May 9, 2006

ULNRC-05281

**DOCKET NUMBER 50-483
CALLAWAY PLANT
UNION ELECTRIC CO.
APPLICATION FOR AMENDMENT TO
FACILITY OPERATING LICENSE NPF-30
ADOPTION OF INDUSTRY TRAVELER TSTF-490**

~~Figure 3.4.16-1 (page 1 of 1)~~
~~Reactor Coolant DOSE EQUIVALENT I-131 Specific Activity~~
~~Limit Versus Percent of RATED THERMAL POWER~~

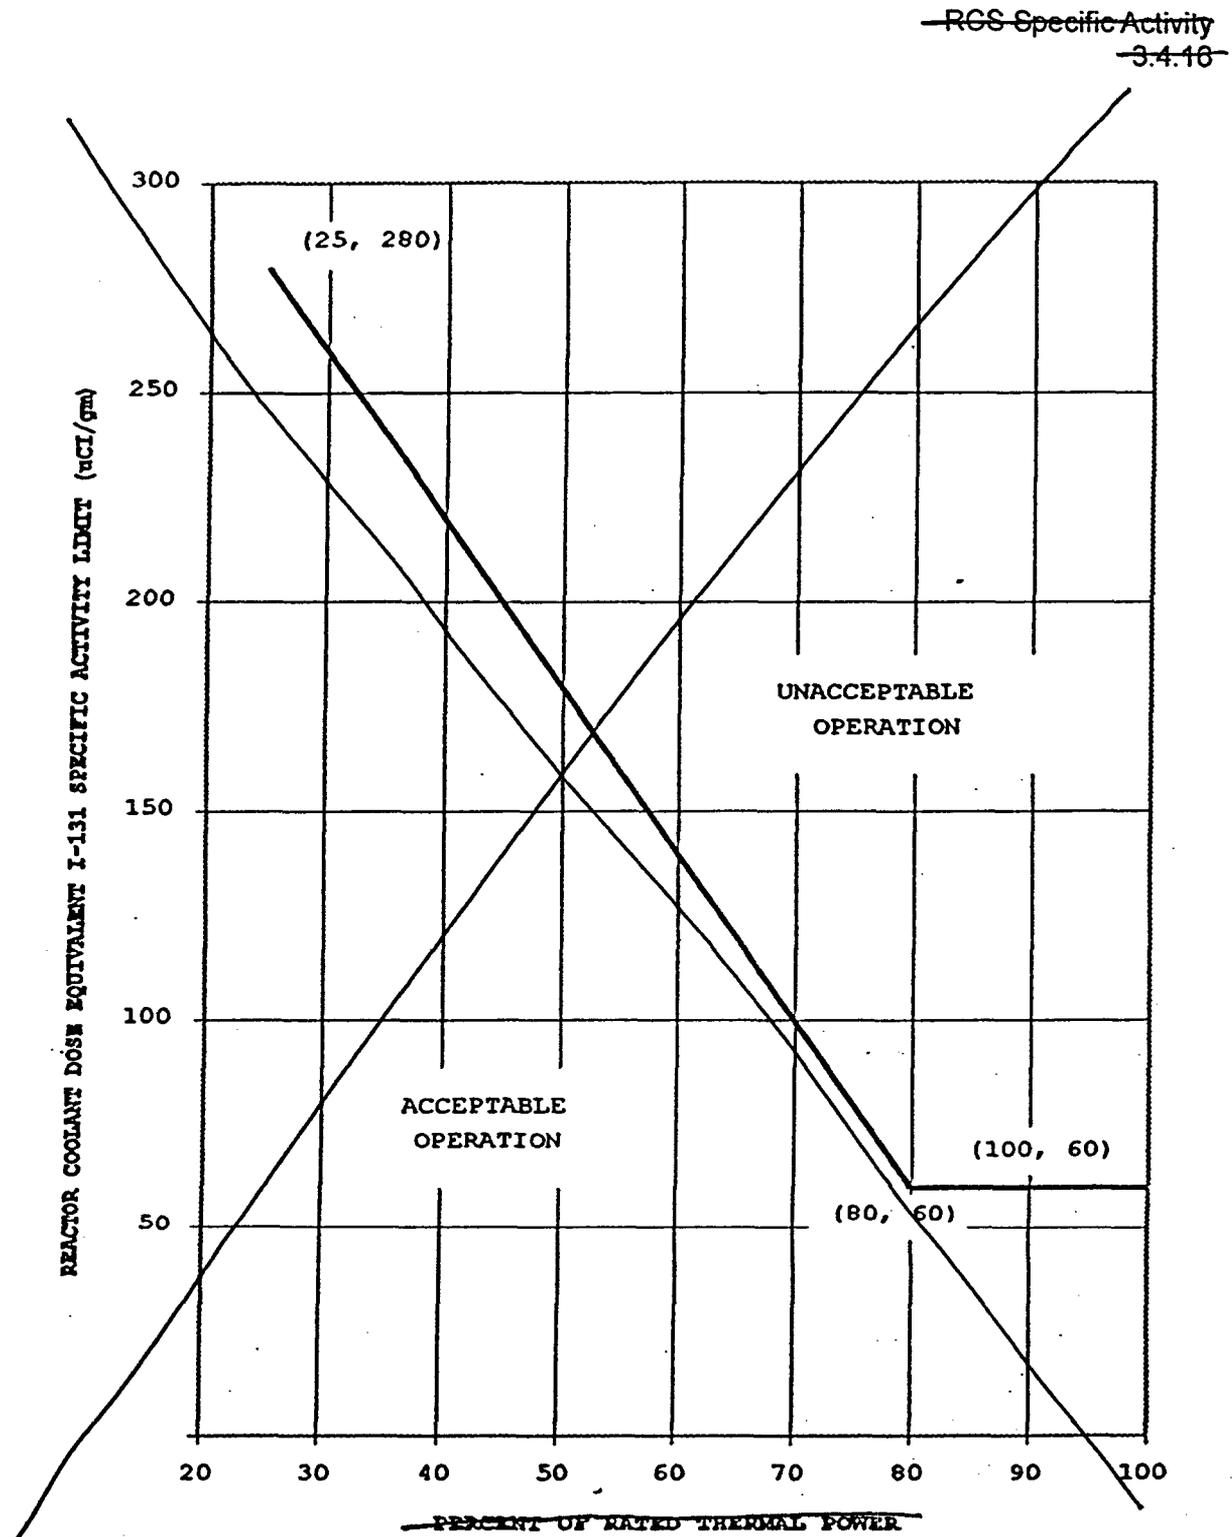
The current TS Figure 3.4.16-1, "Reactor Coolant DOSE EQUIVALENT I-131 Specific Activity Limit Versus Percent of RATED THERMAL POWER" would be deleted.

TS 3.4.16 Required Action A.1 is modified to remove the reference to Figure 3.4.16-1 and insert a limit of less than or equal to 60 $\mu\text{Ci/gm}$ for DEI.

The curve contained in Figure 3.4.16-1 was initiated by the AEC in a June 12, 1974 letter from the AEC on the subject, "Proposed Standard Technical Specifications for Primary Coolant Activity." However, this letter does not provide any technical basis for the curve.

The Case 2 radiological consequence analyses for SGTR and MSLB accidents that take into account the pre-accident iodine spike do not consider the elevated RCS iodine specific activities permitted by current TS Figure 3.4.16-1 for operation at power levels below 80% RTP (i.e. DEI of 60 $\mu\text{Ci/gm}$ at 80% RTP increasing linearly to [225] $\mu\text{Ci/gm}$ at [25%] RTP). Instead, the Case 2 analyses assume a DEI concentration 60 times higher than the corresponding accident's Case 1 analysis assumption [which corresponds to the 60 $\mu\text{Ci/gm}$ specific activity limit associated with 100% RTP operation as discussed in Section 3.1 above]. Therefore, TS 3.4.16 Required Action A.1 should be based on a limit of 60 $\mu\text{Ci/gm}$ to be consistent with the assumptions contained in the radiological consequence analyses. It is not expected that plant operation at reduced power levels would result in iodine specific activity levels that exceed the 60 $\mu\text{Ci/gm}$ upper limit defined for full power operation.

"Verify DOSE EQUIVALENT I-131 $\leq 60 \mu\text{Ci/gm}$."
